## Addendum #2

### Unified Communications, Paging/Public Address System and Clocks and Bells System

**Issue Date: Thursday, April 20, 2023**

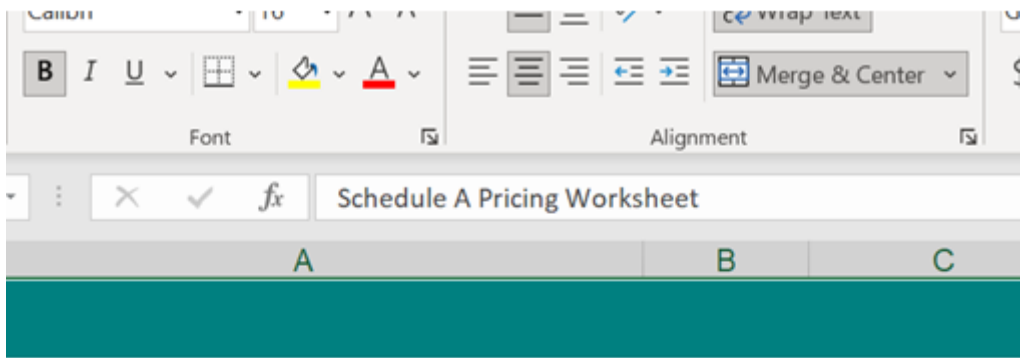
- b. Note: Most of the existing phone systems cannot support SIP trunks
10. 10 of the 40 sites already have a fairly new phone system (NEC) that can be reused. (about 600 phones total). How do we enter this factor into the excel spreadsheet?I know they did not want us to “edit” the spreadsheet, however, I was thinking that I would lower the quantity of phones on the spreadsheet from 1699 to 1099. Another question about what I see when opening excel spread sheet. What should I select?

Please see updated spreadsheet on <https://www.providenceschools.org/domain/2666> and BidNet Direct
